## MEMORANDUM

RE: Supplement to Fill Water-Bearing Zone Groundwater Evaluation – Northern Portion of the Siltronic Corporation Property, Portland, Oregon ESCI No. 183

## **RESPONSE TO DEQ COMMENTS**

Figure 9  
OW-2F and Willamette River

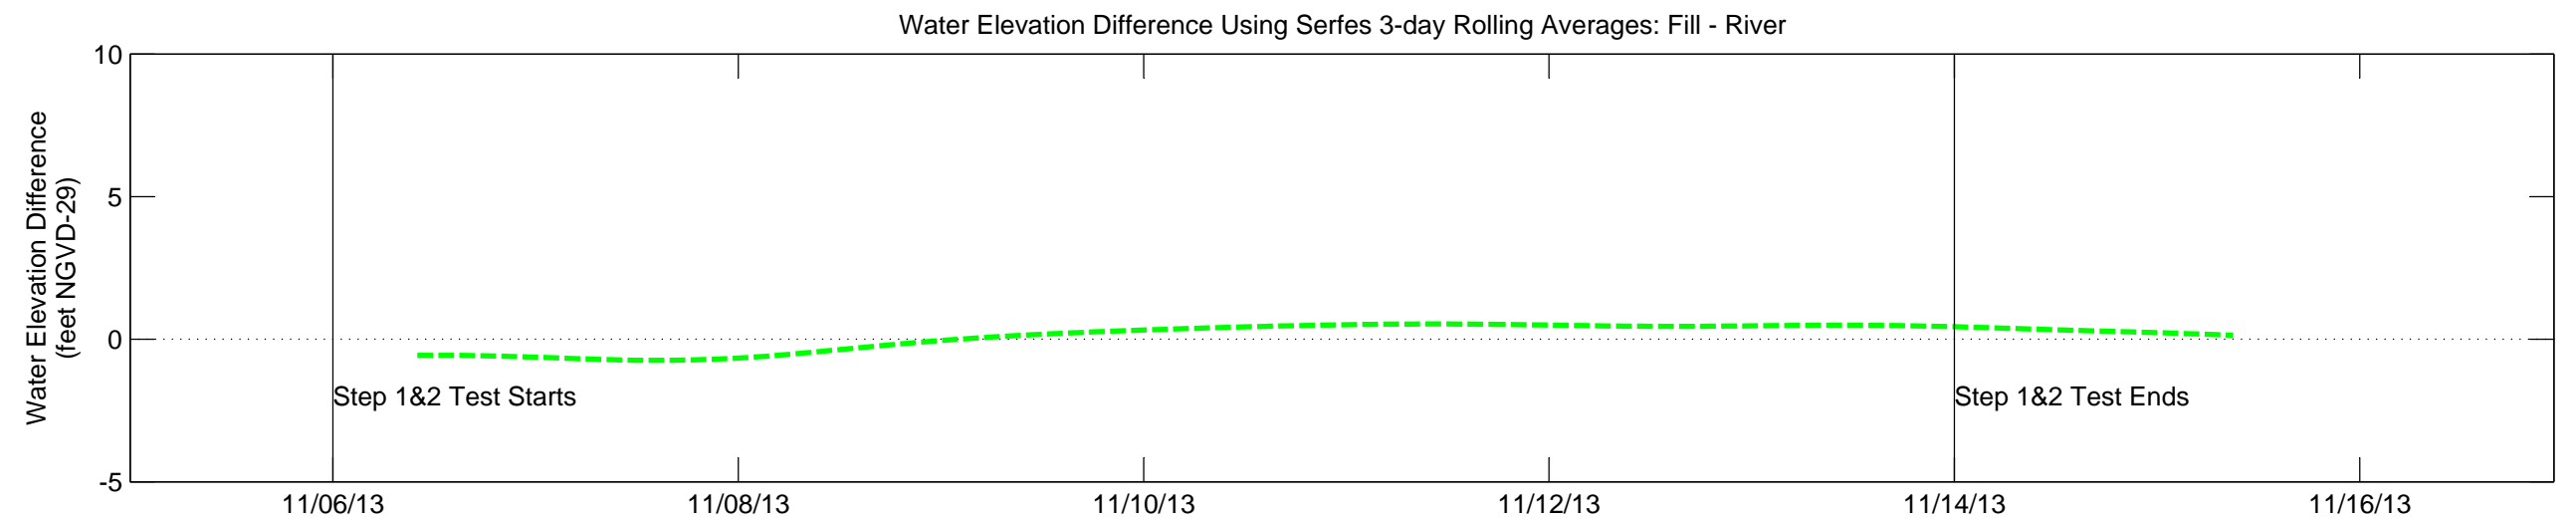
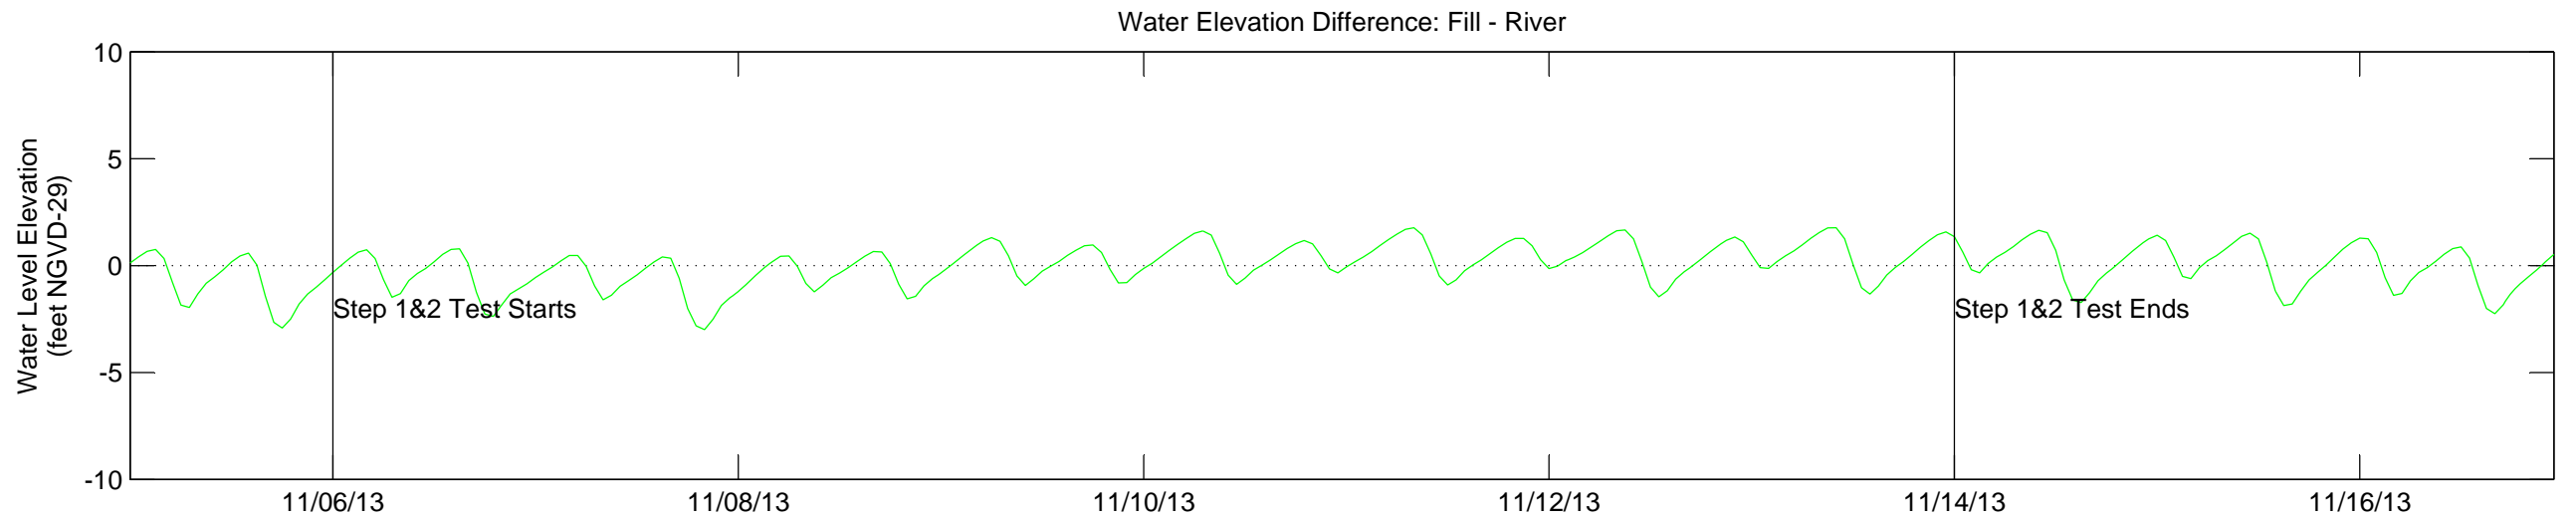
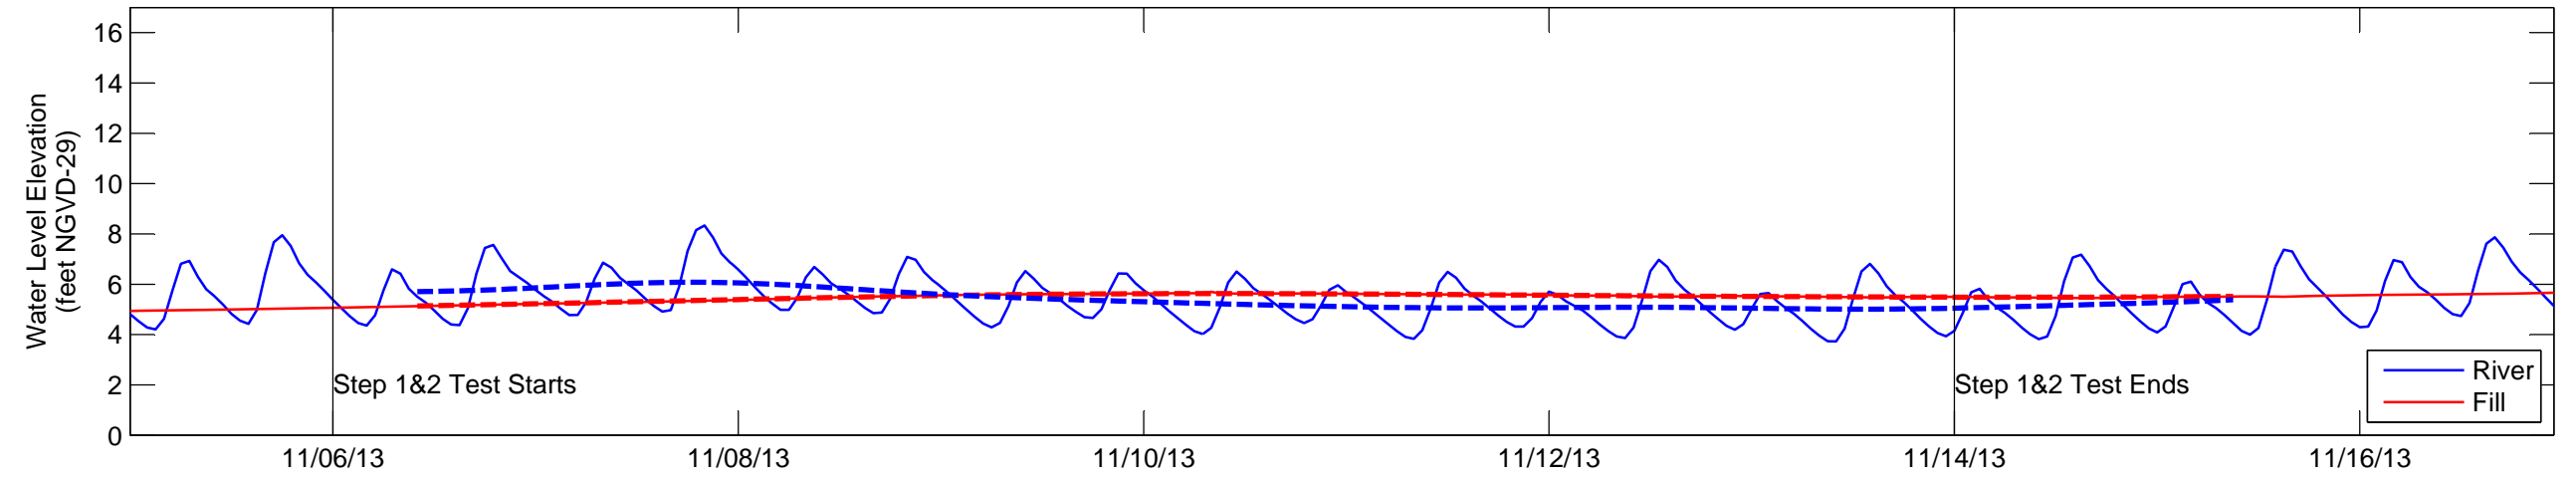
**DEQ Specific Comment:** “Siltronic indicates that water levels in WS-42-29 [sic] declined 1.24-feet during the Phase 1 Step 6 test. The basis for this conclusion is not clear to DEQ as the decrease in water levels shown by Figure 13 do not appear to be reflected in Figure 9. DEQ requests that Siltronic provide additional information and data to support the interpretation in the supplement to the Fill WBZ Evaluation.”

**MFA Response to Comment:** In the Fill WBZ Evaluation, MFA observed that water levels at WS-44-29 fell below the installed depth of the transducer (which is installed 1.24 feet above the top of the confining layer). This means that during the Phase 1, Step 6 test, water levels at WS-44-29 dropped below the recordable range of the instrument to an elevation near the confining layer (i.e. the Fill WBZ was dewatered).

WS-44-29 water levels shown in Figures 9 and 13 do not differ; the water level in the later part of the Step 6 test was approximately 4.9 feet (NGVD-29) in both plots. A red line is used to indicate groundwater elevations in WS-44-29 in both figures. In Figure 13, the blue line indicates specific conductance, which fell to zero (i.e. the transducer is not in water) at the same time that the water level fell to 4.9 feet (thus the transducer is not in water during the latter portion of the Step 6 test).
